**Final Peer Review Report**  
**For the District's**  
**Recommended Minimum Flows for**  
**Charlie Creek**

AGREEMENT NUMBER: 23CN0004217

SOUTHWEST FLORIDA WATER MANAGEMENT DISTRICT  
2379 BROAD STREET  
BROOKSVILLE, FLORIDA 34604

NOVEMBER 2023

**Figure 2.1: Elevation profile of soils, hydrologic indicators, and vegetation communities along Charlie Creek transect 1, Reproduced from 2012 HSW Report.**

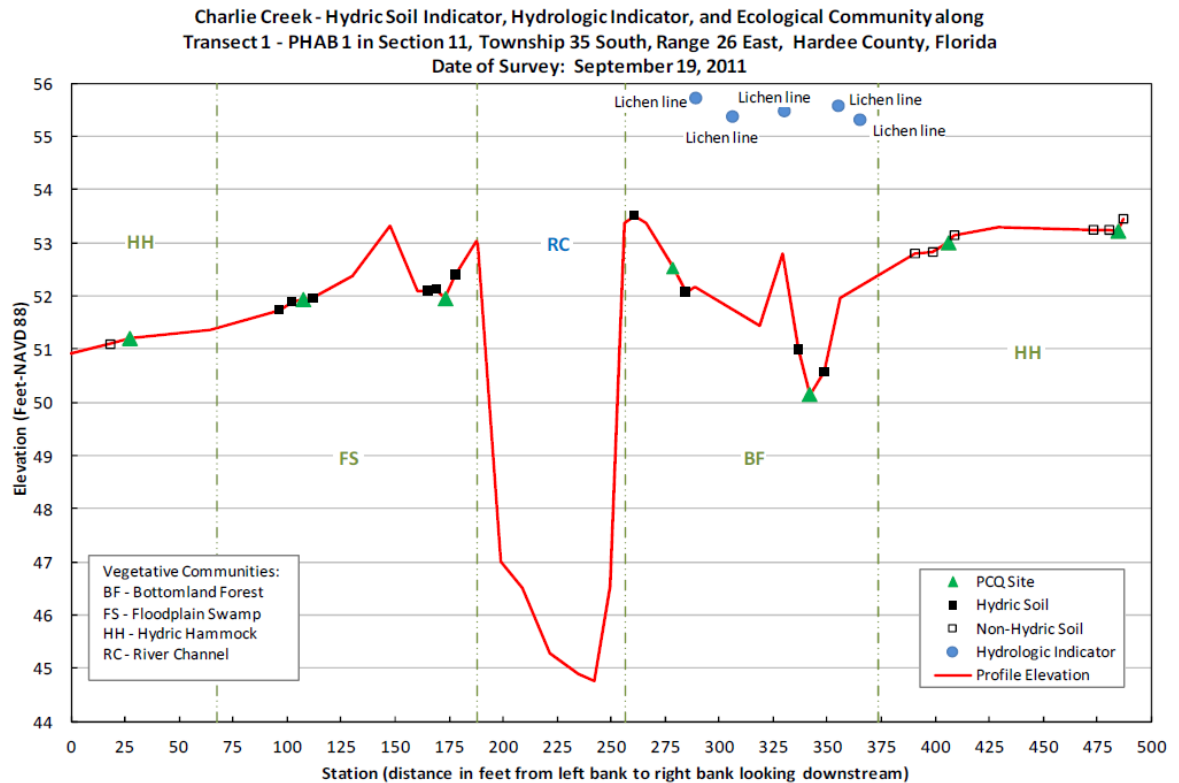
Seven transects (**Figure 2.1**) were collected along Charlie Creek for determining the composition and distribution of plant communities, occurrence of hydric soils, and other hydrologic indicators. Elevation data were also collected in relation to these occurrences so that further analyses could be conducted by the District. Floodplain Swamp, Bottomland Forest, Hydric Hammock, and Upland Hammock were characterized. This information appeared sufficient to the Panel, but data were only collected in the lower 16-miles of the Creek.

Five sites were selected for collecting data for the System of Environmental Flow Analysis (SEFA) to provide the necessary channel habitat and hydraulic data to model potential changes in available suitable habitat for fish and invertebrates under flow reduction scenarios. Field data were collected during low, medium, and high flow ranges and at pool, run, and shoal habitats at each site. It has been requested that additional descriptions of these transect types be provided to improve repeatability for future efforts.

**Figure 2.2: Flow Blocks superimposed on a hydrograph of median observed daily flow representing a typical calendar year. The horizontal lines represent Flow Block divisions.**

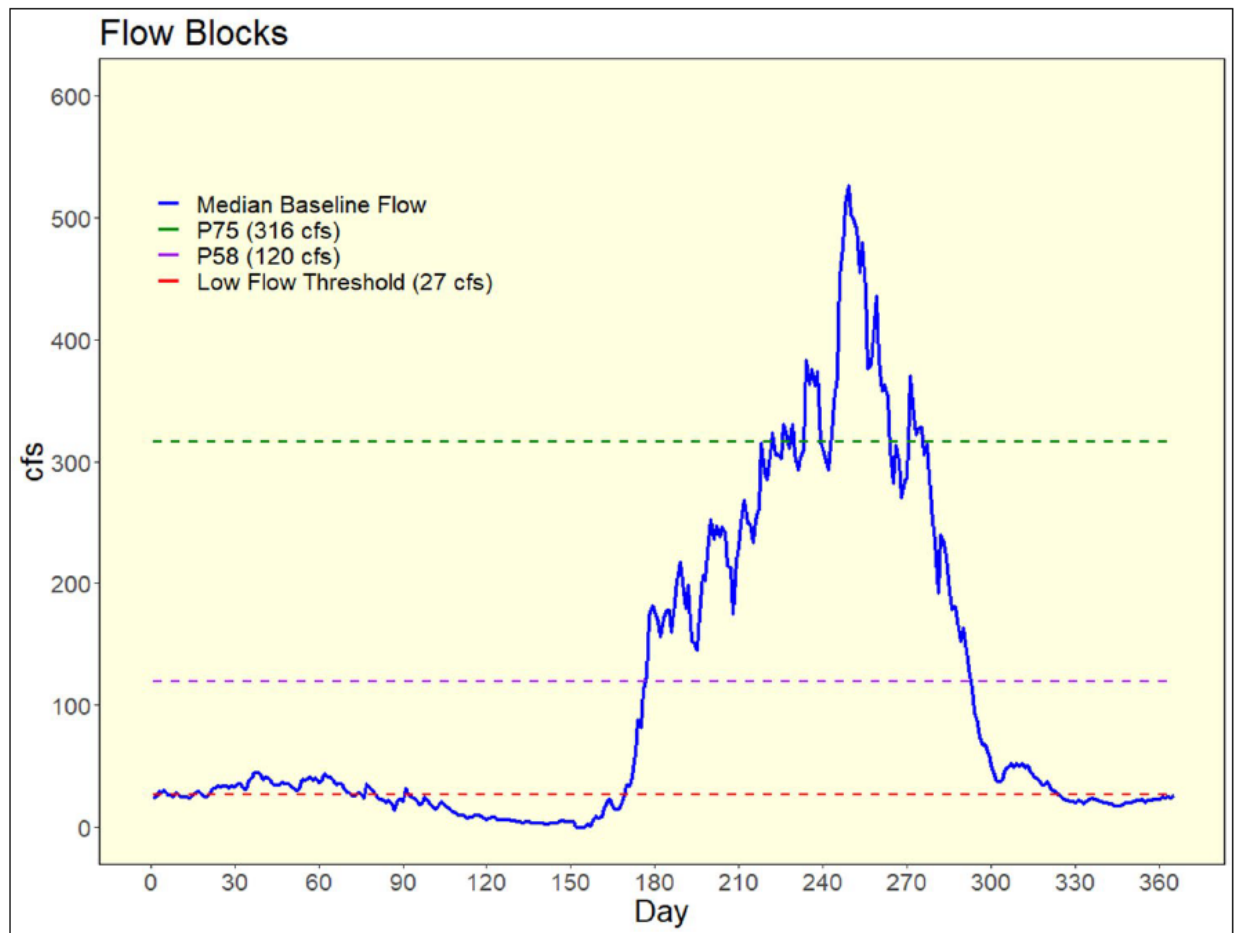
The structure of the four Flow Blocks (Figure 2.2) is well-conceived and protective of all Water Resource Values. This is a progressive and robust assessment. Blocks 1 and 2 were protected by evaluating multiple specific habitats and functional features in each block and were set using the most protective metrics at the most-sensitive location among multiple positions in the study area. The approach taken there is specific, prudent, balanced, and highly intuitive toward addressing the key functions in those blocks.

Blocks 3A and 3B were derived primarily from a statistical analysis of the lower and upper portions of the floodplain area inundation, without directly addressing the requirements of specific habitats or processes in that part of the flow regime. Further, a block-specific average percent of flow reduction (PFR) was, respectively, recommended as the minimum flow for Blocks 3A and 3B. This results in a less protective approach versus using the highest flow in each block.

Block 3A includes the lowest-lying and most-deeply and frequently-wetted alluvial floodplain surfaces and communities that are wetted between the 58<sup>th</sup> and 75<sup>th</sup> percentile flow. This block straddles bankfull flow. Bankfull flow is perhaps the single most important discharge for sustaining in-stream channel pattern and dimension, and its distribution of habitat substrates. It warrants specific attention and appears to be indirectly but sufficiently protected by this approach in this case.

Block 3B contains habitats that occupy elevations associated with 75<sup>th</sup> to 99<sup>th</sup> percentile flow profiles. Substantial active alluvial surfaces occur above the average flow stages in that block and the uppermost alluvial substrates and associated biological communities may be unprotected at a 15% reduction of inundation area by using the PFR of the average flow in the block.

**Figure 2.3: Charlie Creek Floodplain Community Relative Elevations to Flow Percentile**

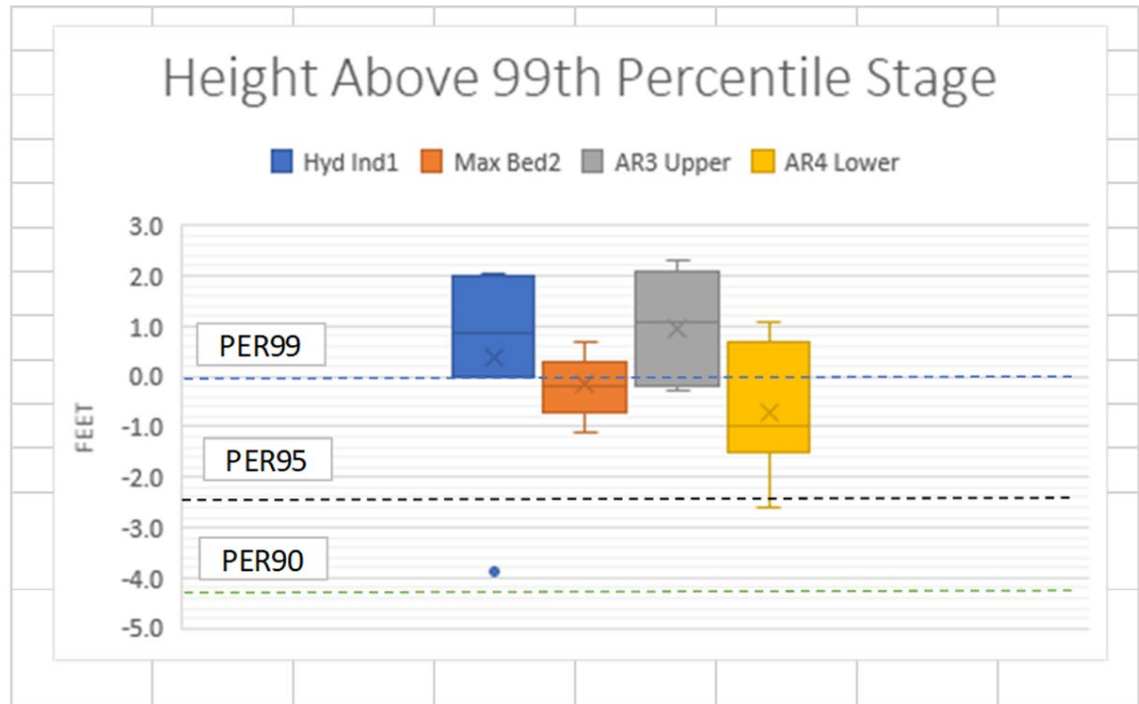
The Panel examined the results of the HEC-RAS model at the vegetation survey sections to confirm protection of each of the major floodplain habitats identified in the vegetation and soils study. The lower alluvial ridges close to the channel margin (AR4) and their associated hydric hammocks (Max Bed2) occur between the 95<sup>th</sup> and 99<sup>th</sup> flow percentiles (**Figure 2.3**). The highest alluvial ridges and upper alluvial valley flats (AR3) are mostly situated at elevations above the 99<sup>th</sup> percentile flow profile.

The District is to be commended for the specificity and wide blanket cast to protect features in Blocks 1 and 2, building upon proven precedents and adding to the sophistication of previous analyses. The methods used for Blocks 3A and 3B are also well thought out for seeking a simple and elegant evaluation method drawing from modeling results, but are not as multiple and as habitat-specific as in the approaches used in the lower in-stream blocks. There is greater uncertainty in this lack of multiple variables and spatial aggregation, and Block 3B has a considerable range of percent-of-flow reduction versus flow percentile across the flow range in the block.

For Block 3A, the Panel finds the narrow range of 12% to 11.1% percent-of-flow reduction does not warrant any further consideration as the result is insensitive to the method taken to select which percent of flow reduction to use within that range. However, Block 3B covers a range of approximately 11% to 6% flow reduction and more care is required in the selection of what part of this range is sufficiently protective of the surfaces and habitats spanning the associated flow range.

To provide greater assurance against significant harm to the upper-most habitats, the panel would like the District to consider splitting the upper portion of that Block into a third floodplain block, Block 3C. A visual break is apparent somewhere near the 94<sup>th</sup> flow percentile. A break near that position would better center the allowable flow reduction for the upper alluvial surfaces and habitats in the floodplain without unnecessarily restricting

withdrawals throughout the entire range of existing Block 3B. Although relevant to the entire study area, this is particularly important for sustaining the upper terrace habitats downstream of the Sweetwater Bridge which may be systematically incising and thus particularly vulnerable to hydraulic abandonment under flow withdrawal scenarios. Block 3C was added by the District to provide better protection in the high flow environment.
